Addendum #2

Project Name: Nebraska Innovation Campus - 4H Building Renovation & NIC Office Building.
Project No.: 11053
Issued: November 13, 2012
Bid Date: Tuesday, November 20th, 2012
Bid Opening: 2:00pm – Private Opening
Location: 728 Q Street Suite C, Lincoln, NE 68508

M10	ENLARGED PLAN
SCALE: 1/4" = 1'-0"	AREA A - PLAZA SIDE ENTRY VESTIBULE - NEW ENTRY FACADE OVER PREVIOUSLY DEMOLISHED BUILDING CONNECTION

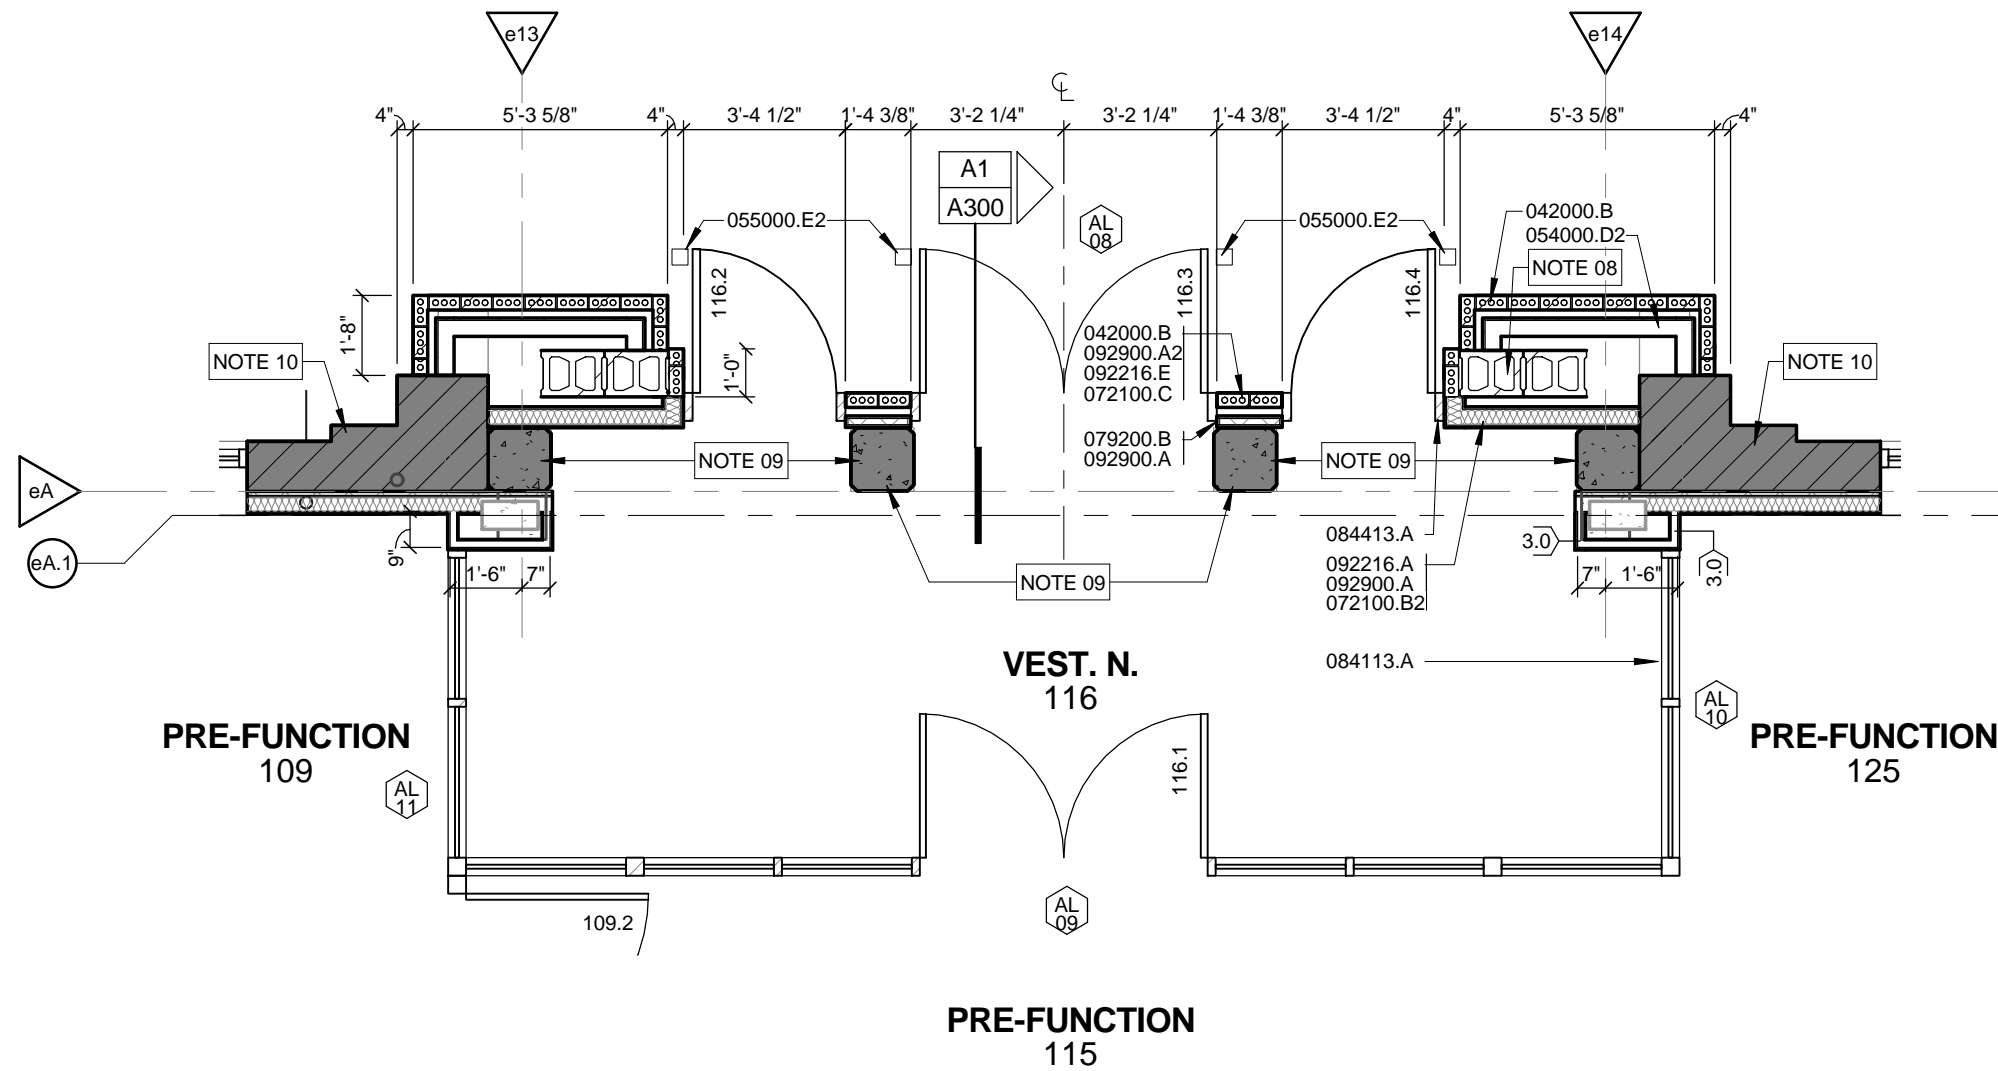
- b. Refer to Pre-Function 109: Interior elevation reference D4/A510 is not used, disregard.
 - c. Refer to enlarged plan M10/A101A: See attachment M10/A101A for new layout at exterior wall.

Reference: A107 DOOR SCHEDULE
 Bid Package 02
Addendum 02
 4H Renovation & NIC Building

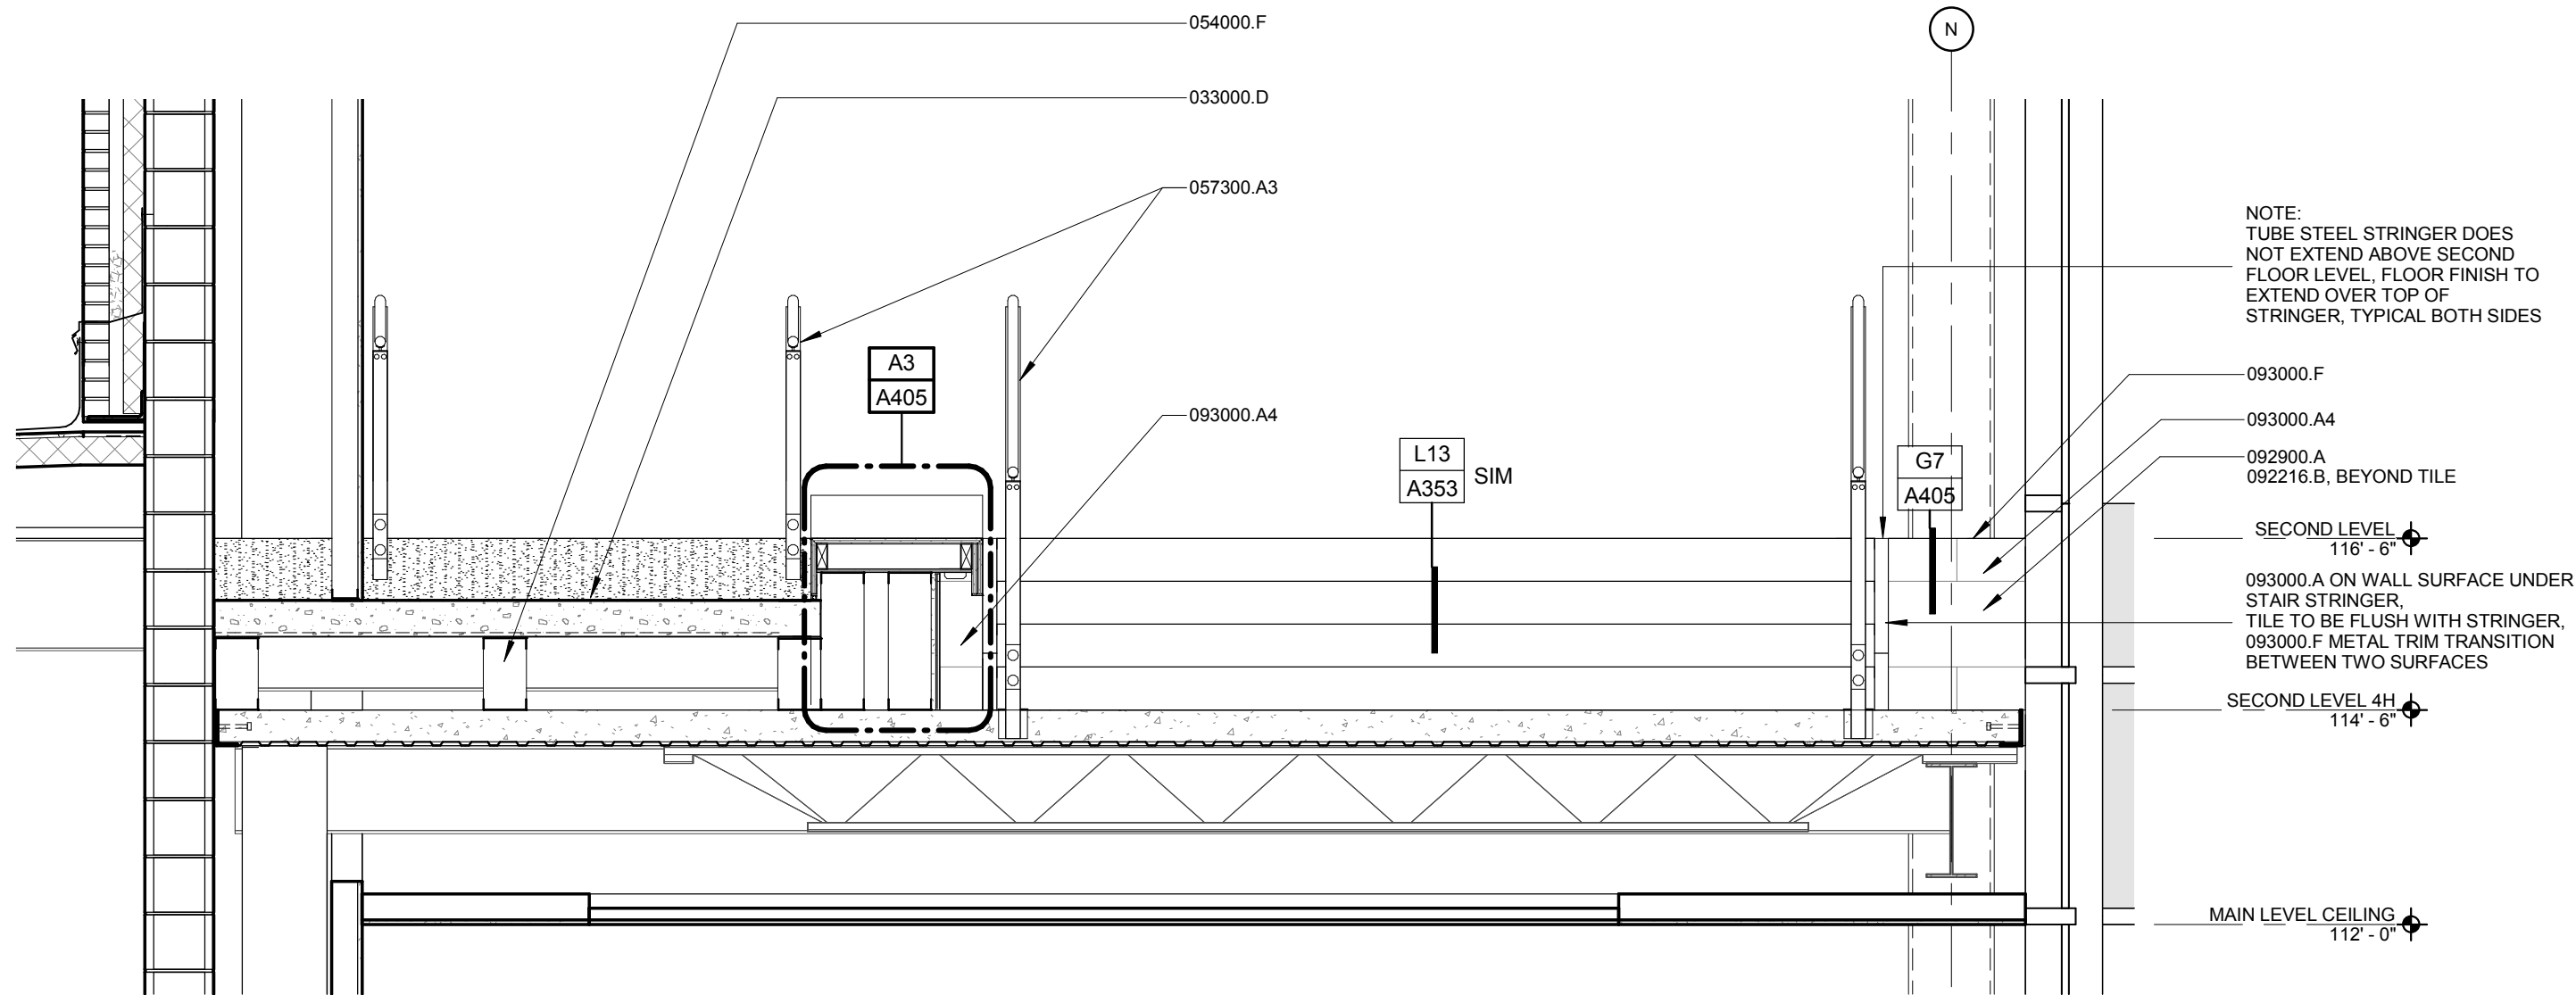
- a. Door frame types coordinated. See attached sketch A107 – Door Schedule.

Reference: G9/A304
Bid Package 02
Addendum 02
4H Renovation & NIC Building

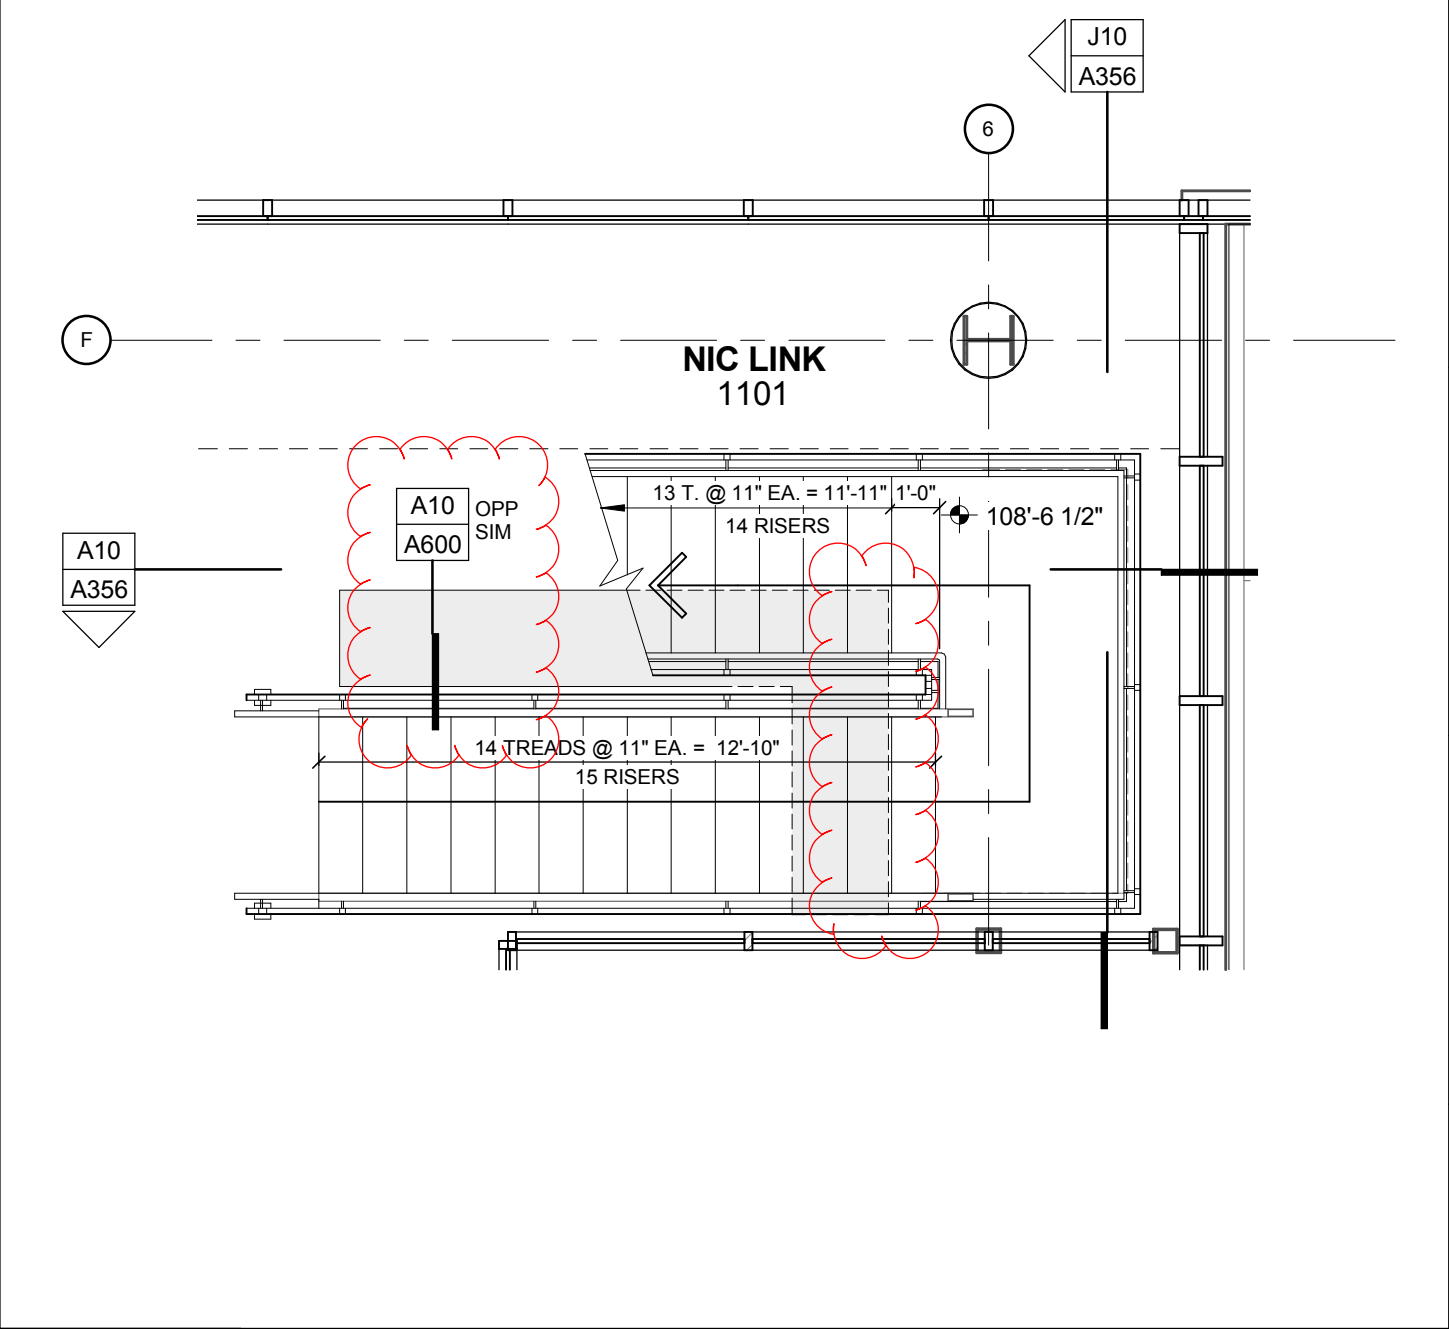
- a. Added drawing G9/A304, section through ramp on the Second Level of the Link Corridor. Added keynote 054000.F. See attached sketch G9/A304.

A7

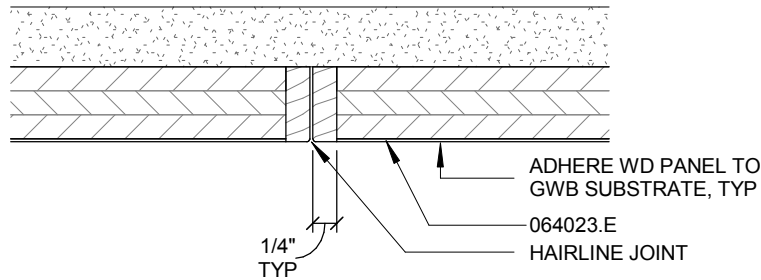
- a. Added detail A7/A405, plan detail of wood paneling at Elevator Lobbies in the NIC building. See attached sketch.
- b. Added A8/A405, plan detail of wood paneling transition to tile at Elevator Lobbies in the NIC building. See attached sketch.

Reference: D10/A405
 Bid Package 02
Addendum 02
 4H Renovation & NIC Building

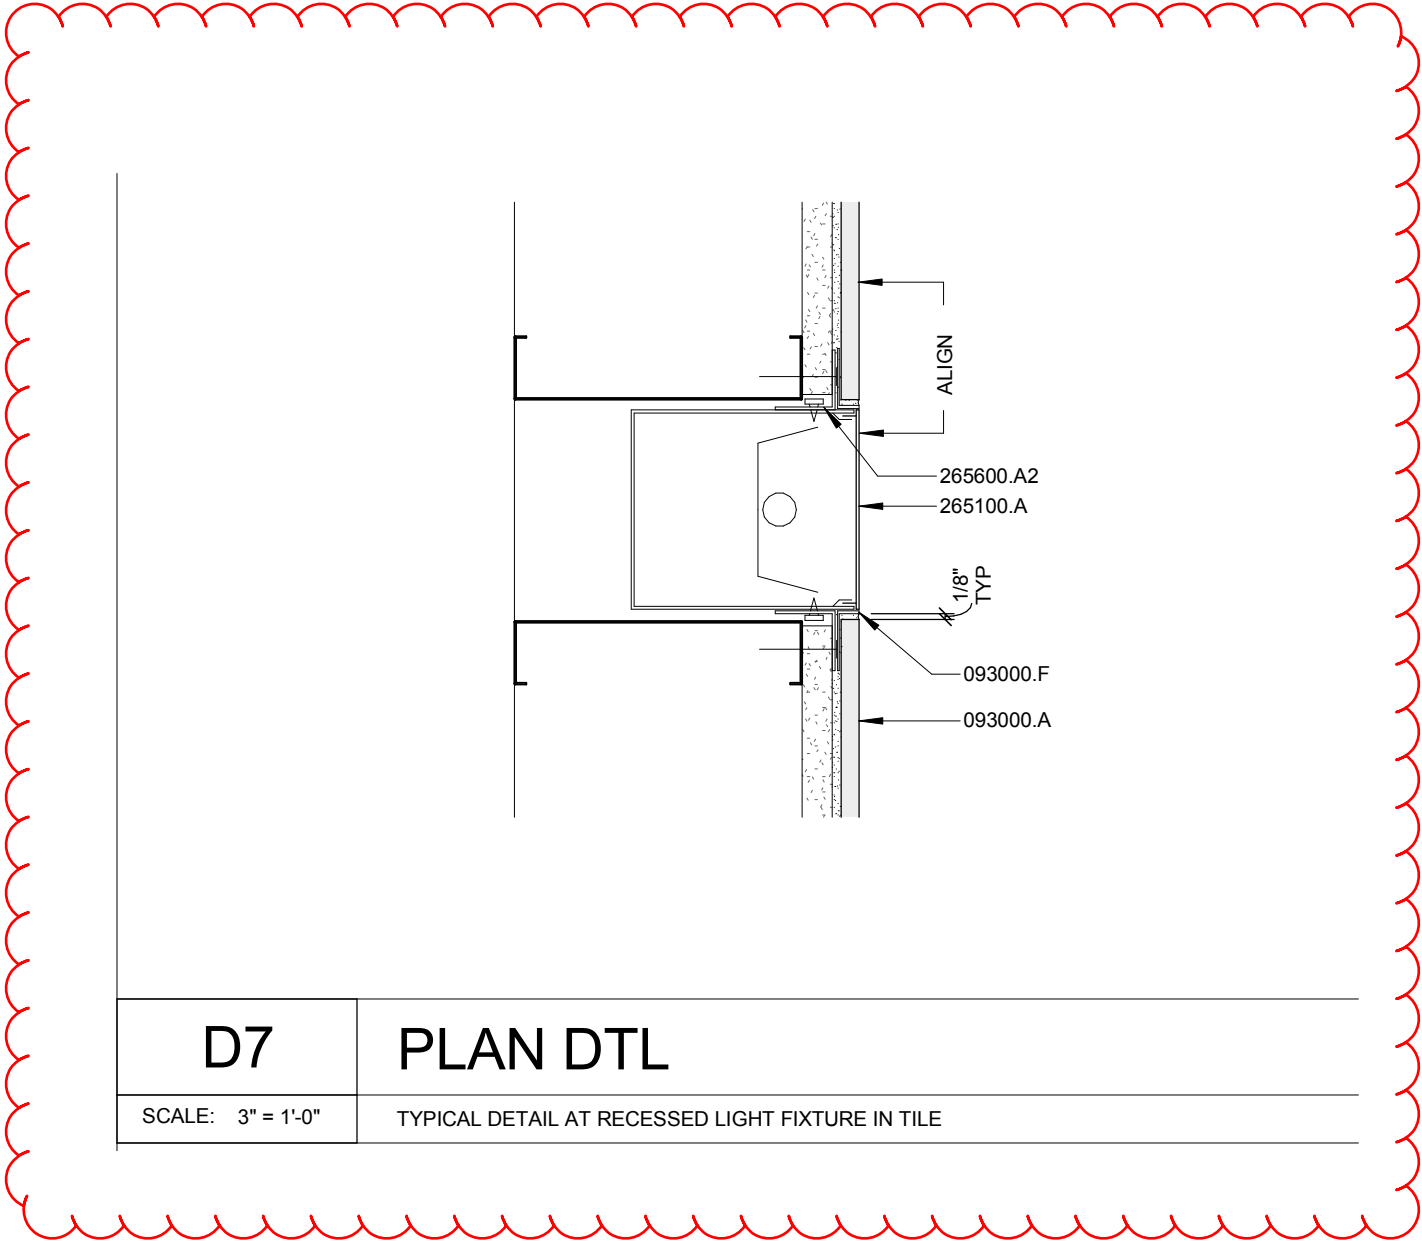
- e. Modified detail G10/A405 to coordinate with wood paneling. See attached sketch.
- f. Modified detail D10/A405 to coordinate with adjacent tile. See attached sketch.

Reference: D7/A405
 Bid Package 02
Addendum 02
 4H Renovation & NIC Building

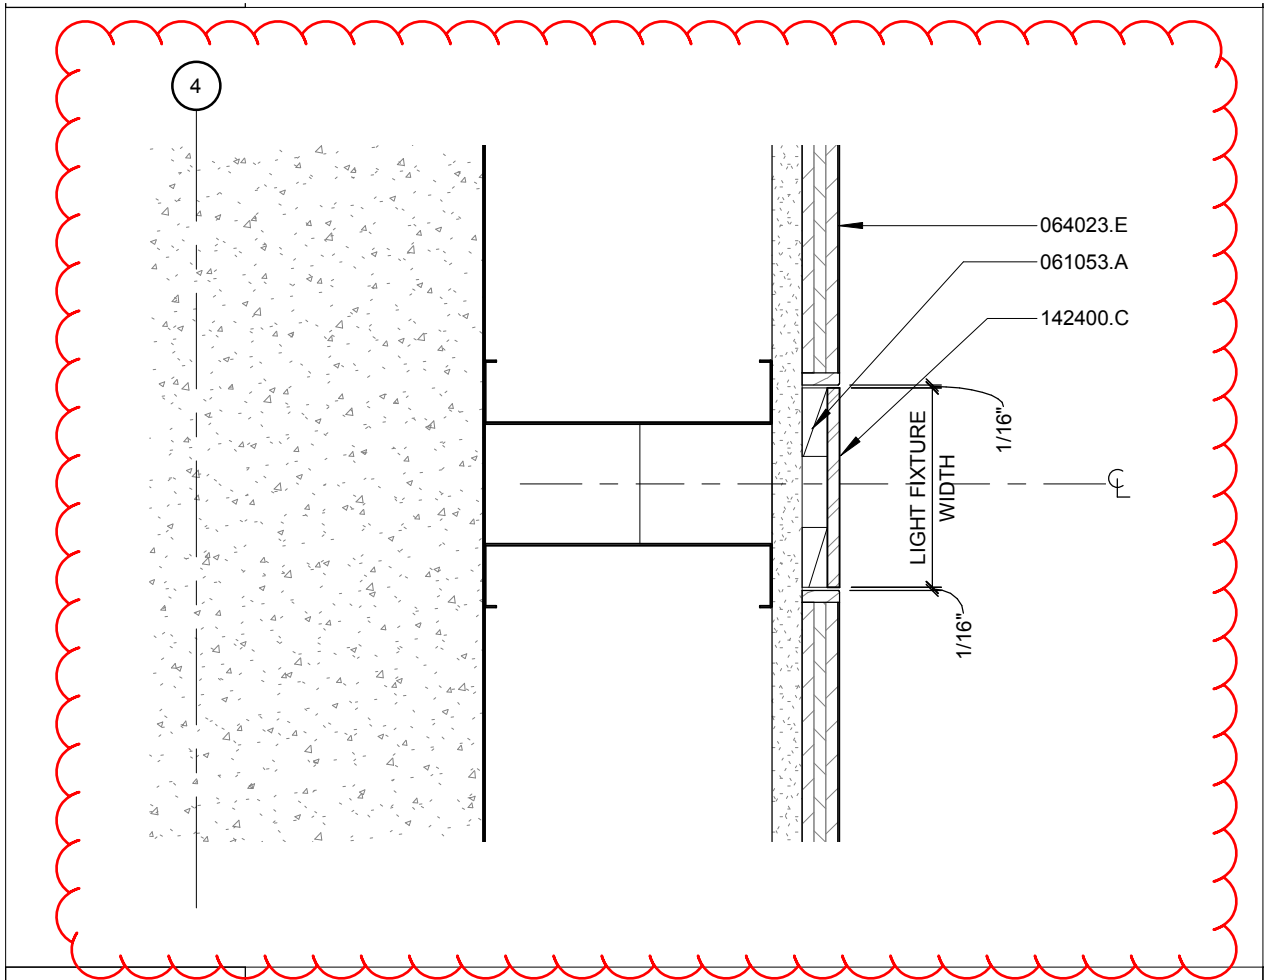
- c. Added detail D7/A405, plan detail of recessed light fixture in tile at Restrooms in both the NIC building and 4H building. See attached sketch.
- d. Modified detail K10/A405, plan detail of recessed light fixture in wood paneling at NIC elevator lobbies. See attached sketch.
